STAFF REPORT FOR THE HISTORIC REVIEW BOARD

FILE NUMBER: DR-14-02, ZC-14-02

REQUEST: Removal of historic resource designation, and design review for a rear porch addition, window replacement, garage replacement, and addition to a rear dormer

② North - Rear Elevation
1/8" = 1'-0"

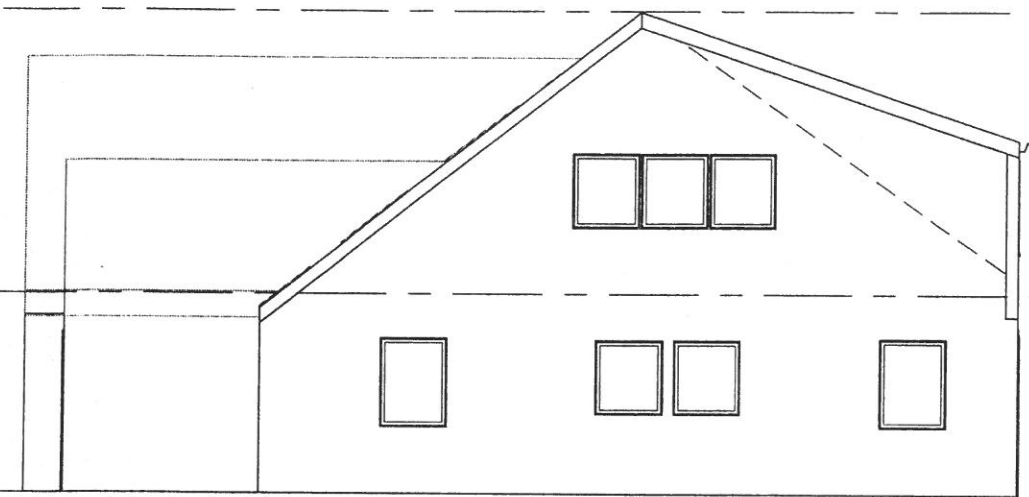
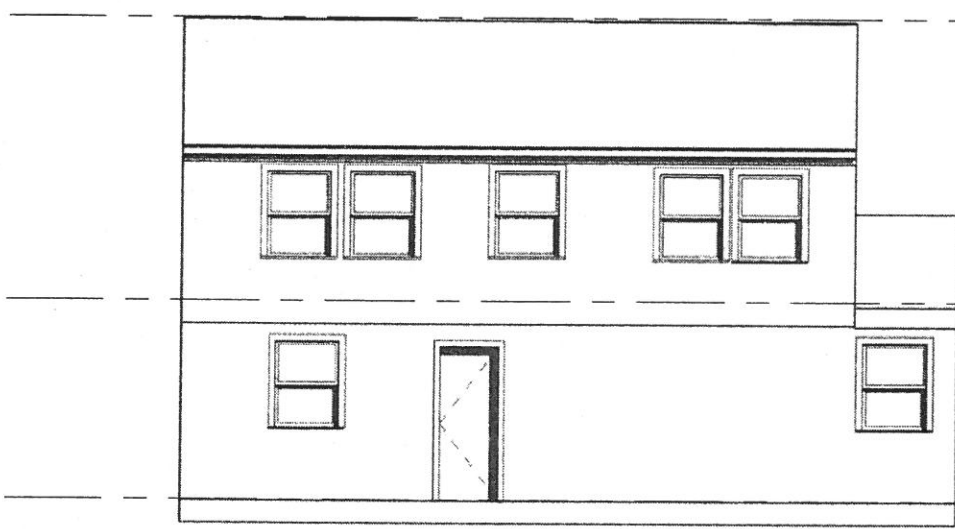
change to it affects the spatial relationships that characterize the property. Staff finds that the criterion can be met if the proposed dormer is set back from the side elevation a distance equal to the set back of the dormer on the southeast elevation. This is addressed in Condition of Approval 2.

1. Site Plan, Elevations, and Narrative. The project shall conform to the plans, elevations, and narrative submitted in Exhibit HRB-5 and 6, except as modified below.
2. Rear Dormer. The addition to the rear dormer shall be set back from the side elevation a distance equal to the set back of the other end of the dormer on the southeast elevation.
3. Windows. The rear porch addition shall, as possible, restore and reuse existing windows.
4. Roof Pitch. The rear porch addition shall have the same pitch as the south/right elevation of the rear shed dormer.
5. Siding. The rear porch addition shall have wood siding.
6. French doors. The French doors in the rear porch addition shall be wood, fiberglass clad, or metal clad that is consistent with the historic appearance.

Photographs of original and replacement windows side by side. Note that the windows are in different positions on the house so the comparison is limited.

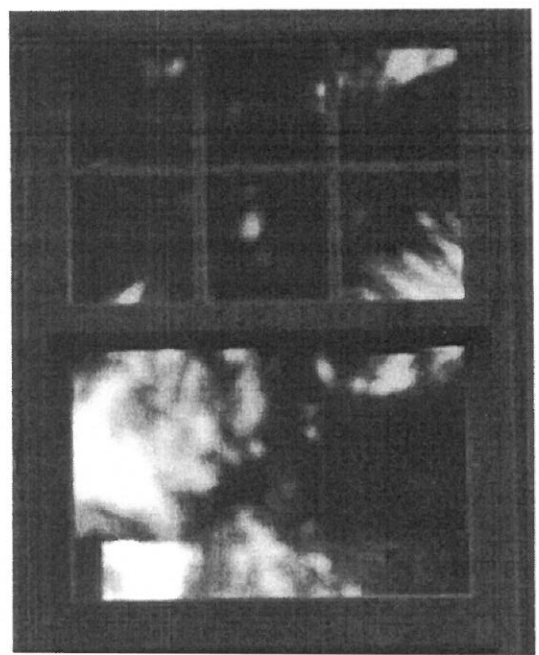
Windows: The proposed window replacement does not retain existing historic material. The proposed windows exhibit similar visual features, including design and muntin and mullion pattern, but do not retain the historic material. If there is significant deterioration where replacement is necessary, the proposed replacements would be appropriate. However, when a historic window is in place, replacement with an alternative material is only appropriate when the window cannot be repaired. The applicant did not provide any evidence in their materials that the windows could not be repaired.
